**MUNICIPAL CORPORATION
KARACHI.**

With reference to your application with plan for Bldg
on plot 117 Sheet No. M.R.I. market Quarter received in this
office on 15/11, I have to inform you that the said plan is approved
and permission to build in accordance therewith is hereby granted. The building must be
erected in conformity with the Bye-laws and rules of the Karachi Municipal Corporation.

PLAN SHOWING THE PROPOSED BUILDING ON LOT

-Nº 117. SHEET M.R.I. MARKET QUARTER-

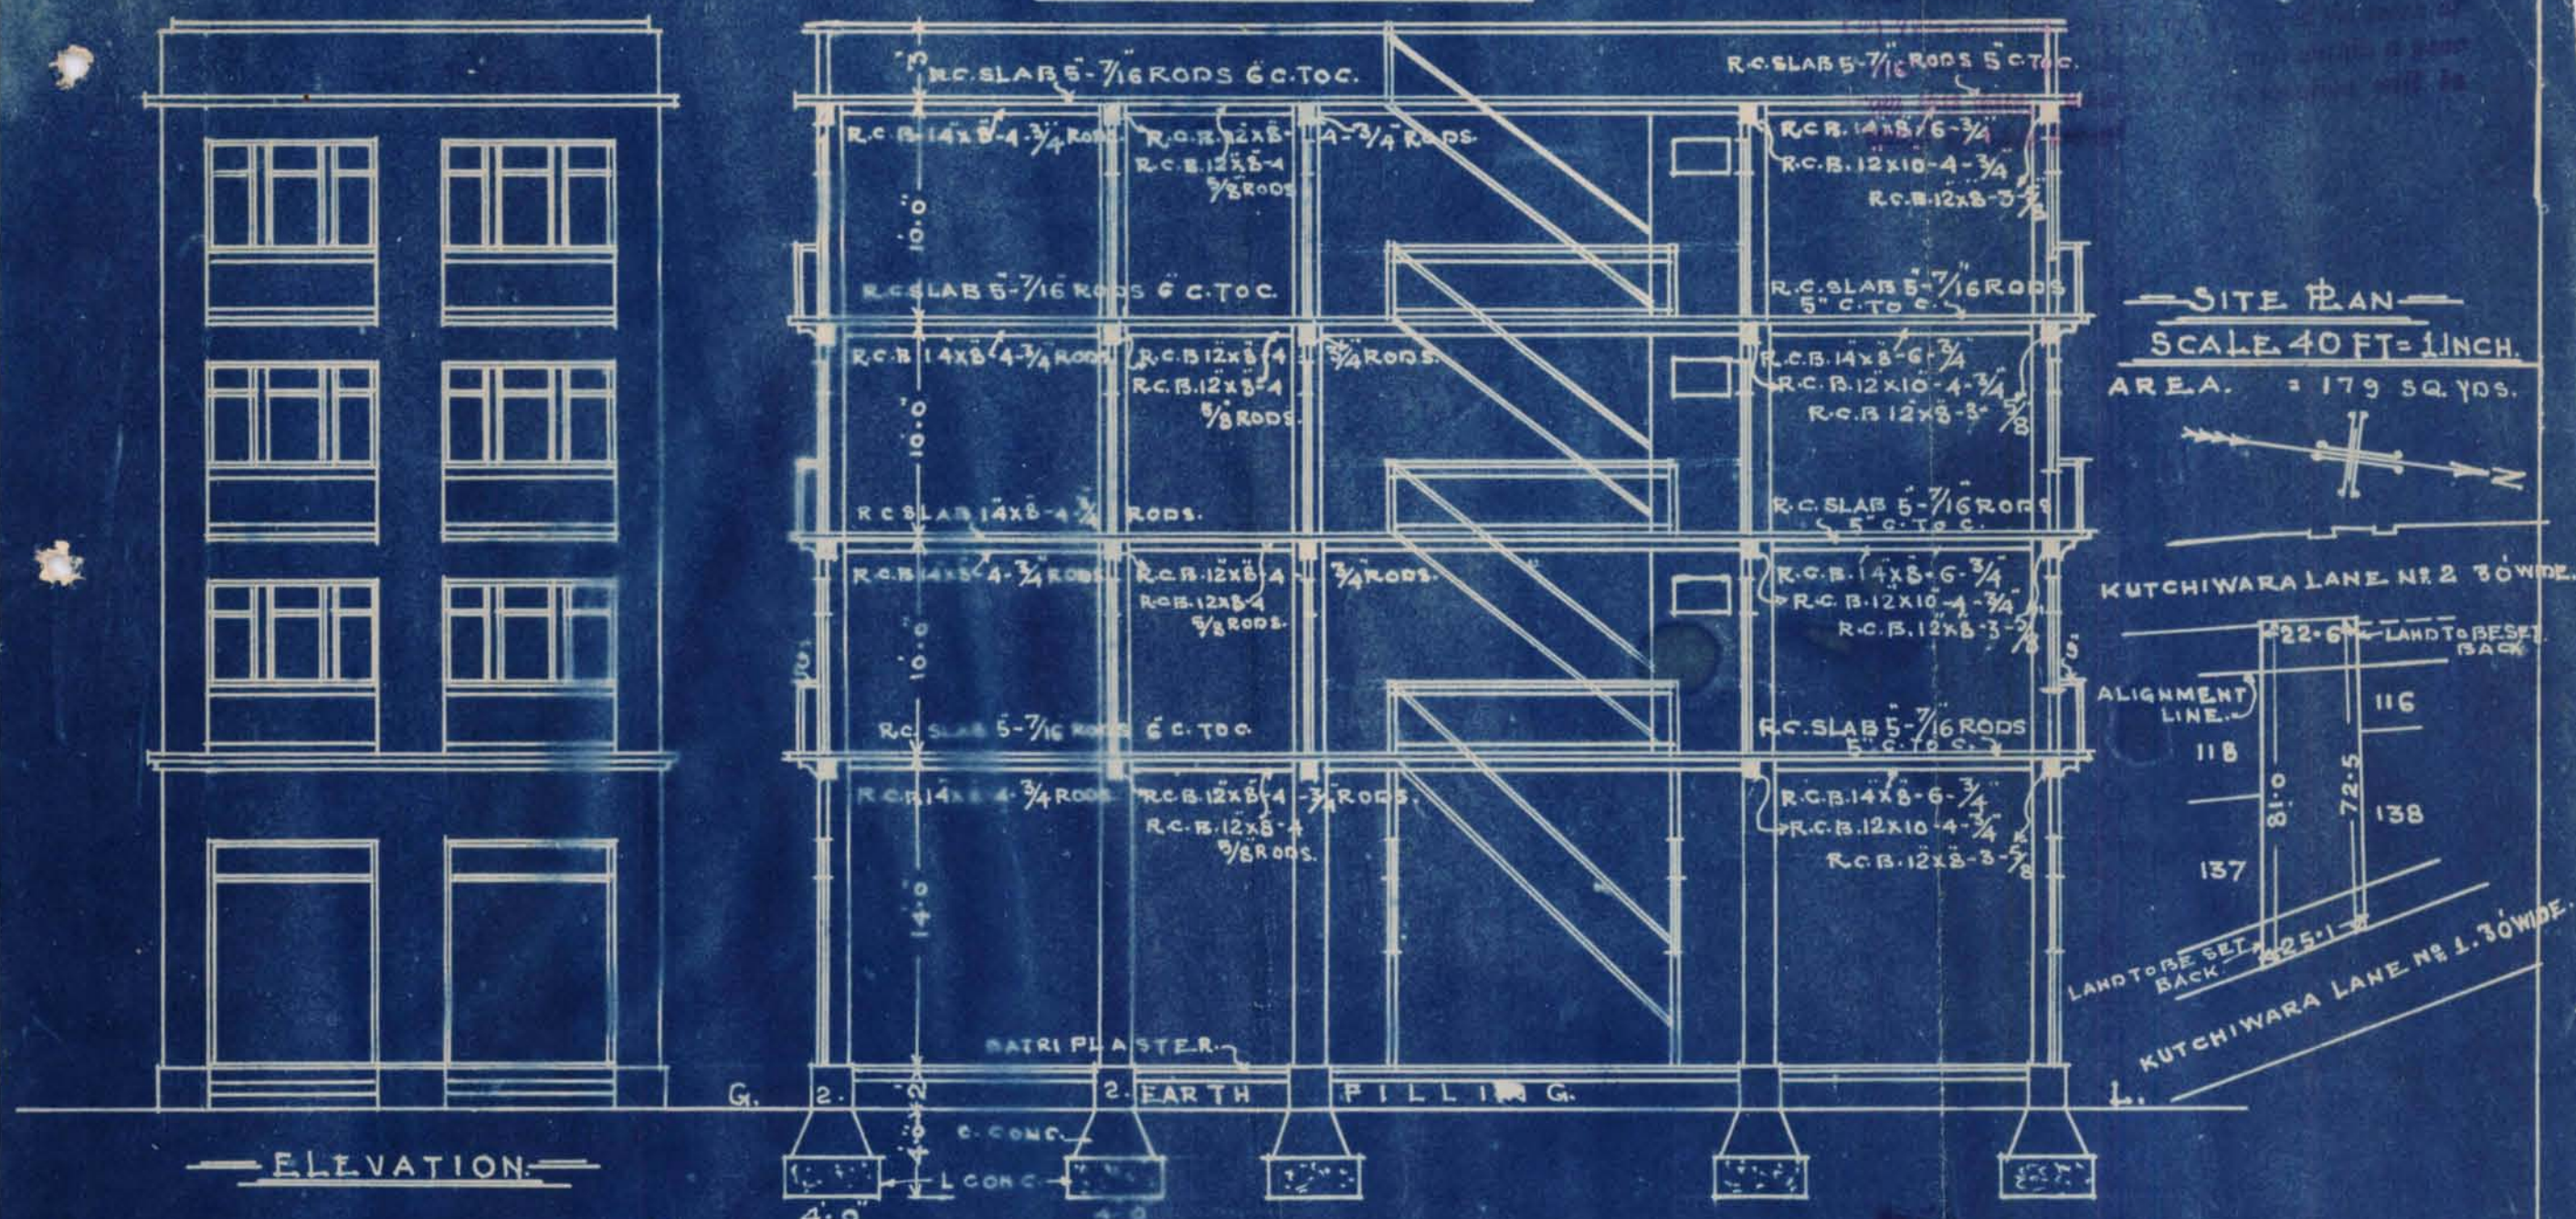
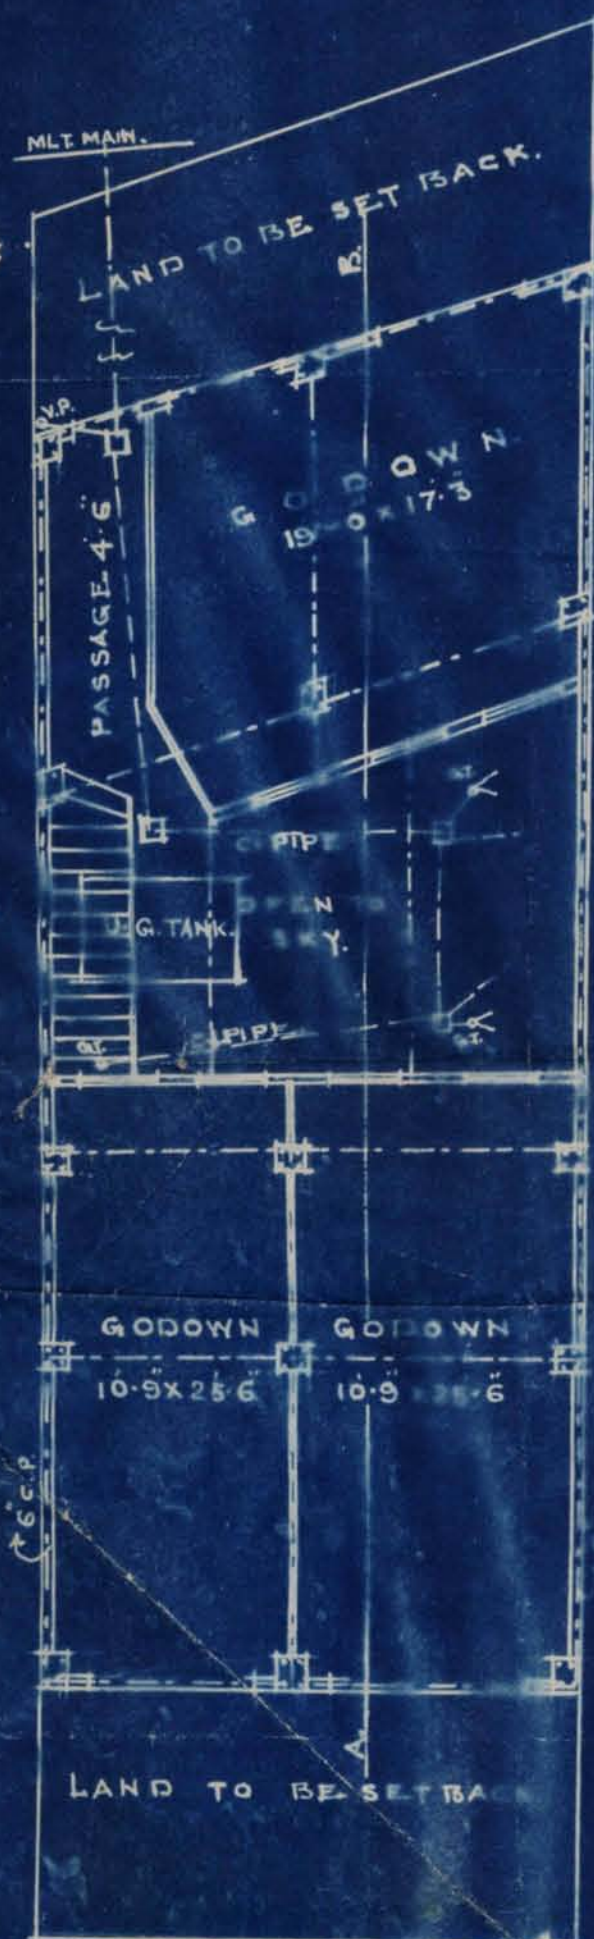
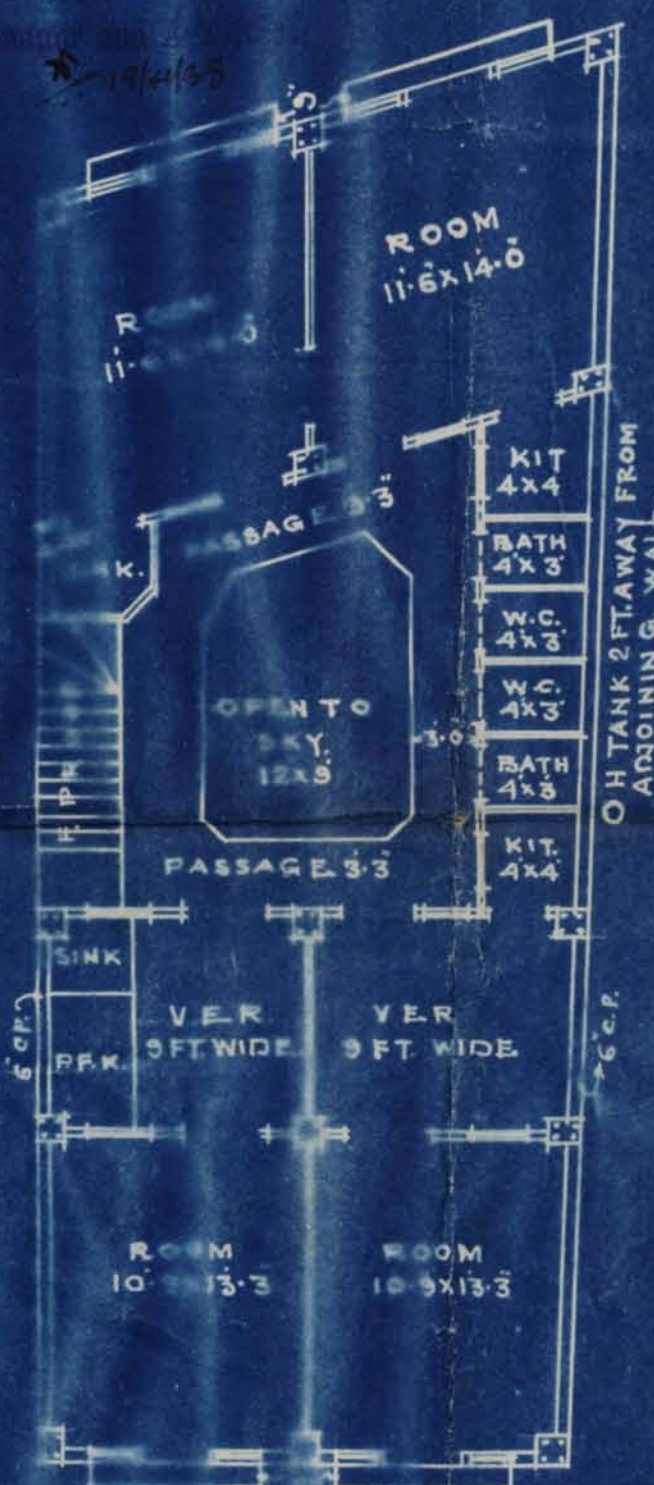
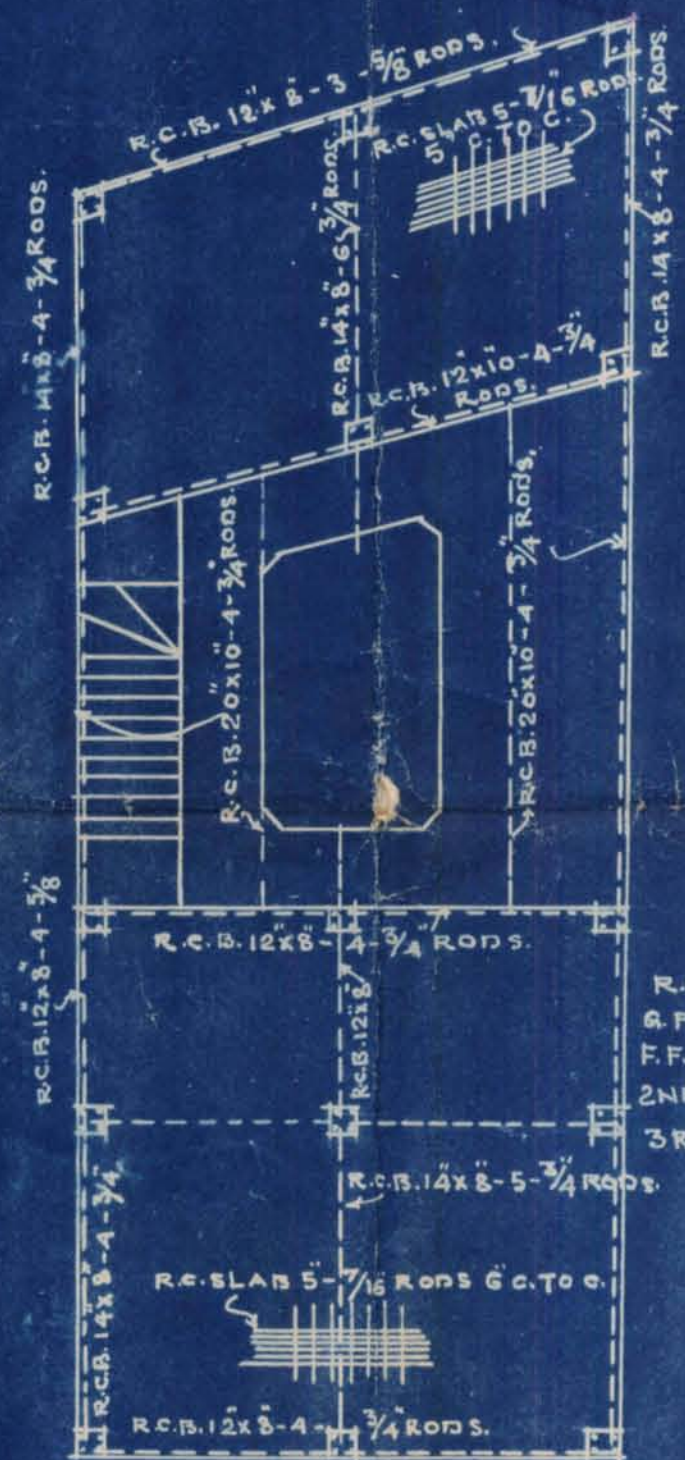
With reference to your application dated _____ 193
for the proposed _____ plan on the above plot, you
are required to submit _____ one more copy of the
correct plan on _____ Clom

with reference to your letter no
BSP 490/38 dated 1-11-38, I am herewith
sending you a correct copy of plan on
cloth as shown

SITE PLAN
SCALE 40 FT. = 1 INCH.

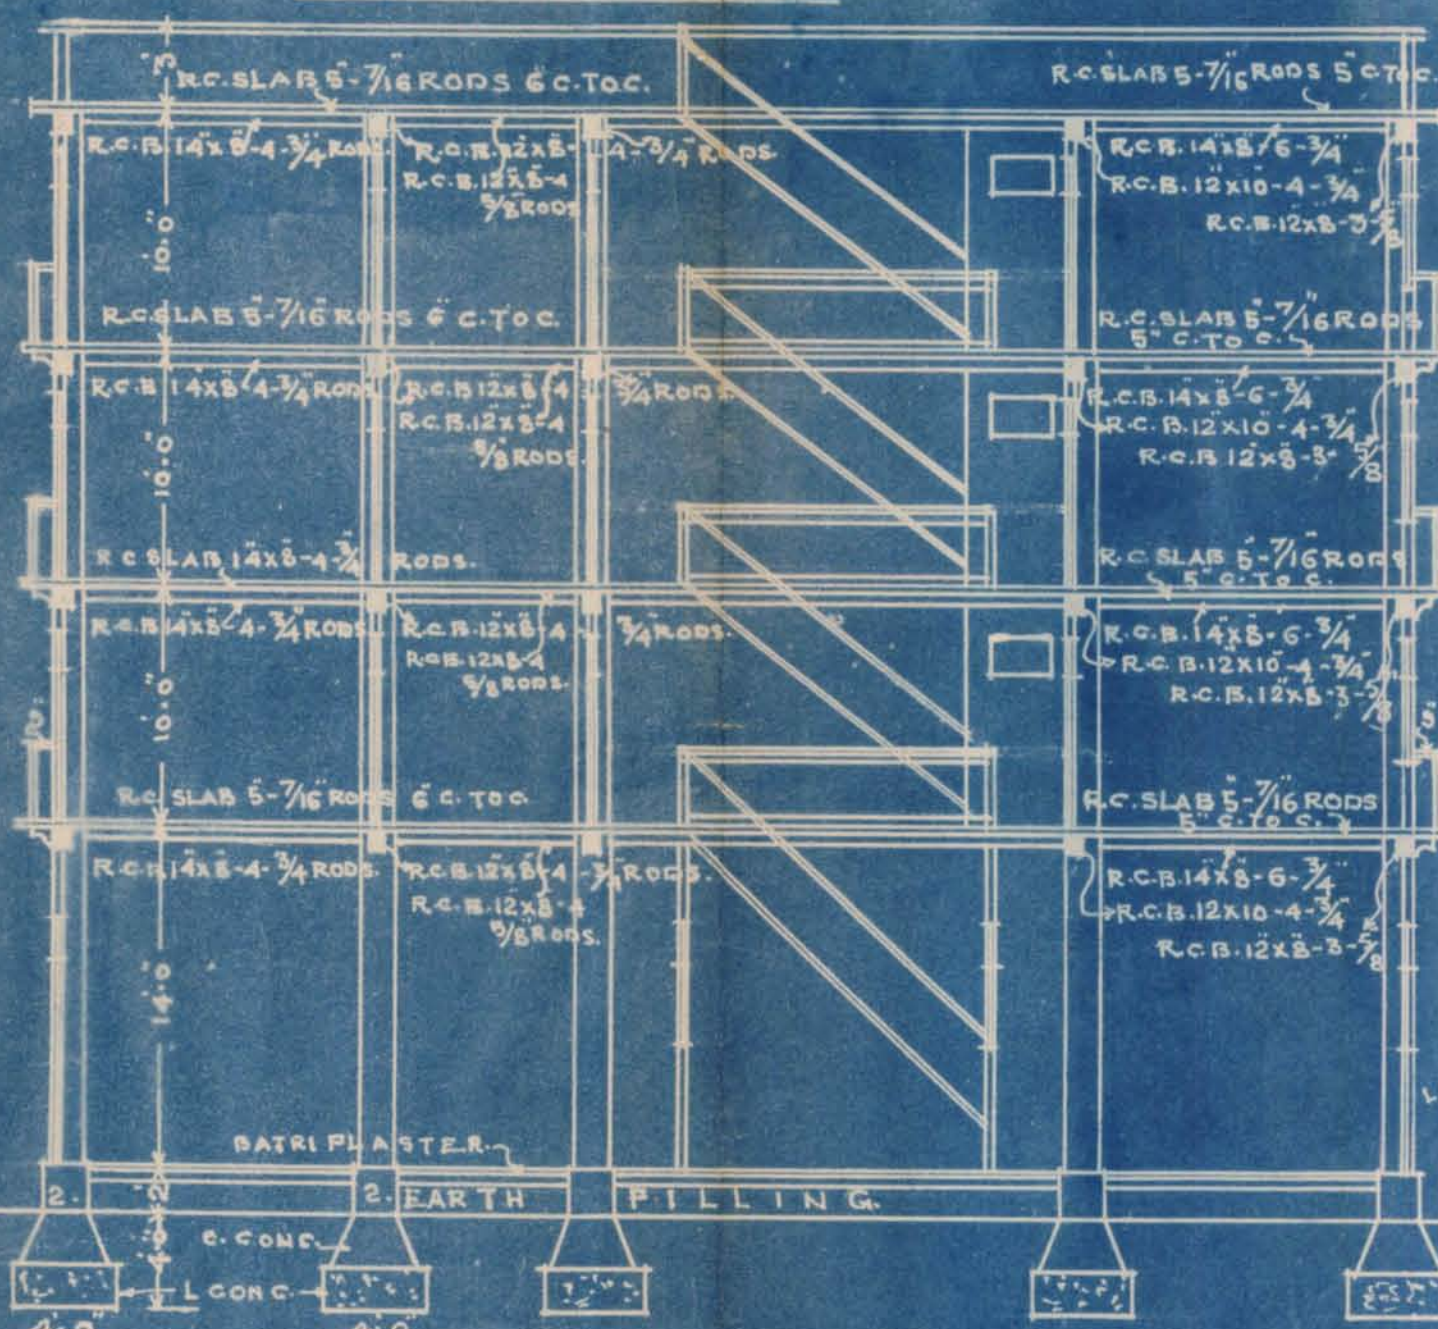
(1) Width of Road and Area of the plot must be correctly shown

L.S. objection complied by the Architect. No objection. 17/4/38.
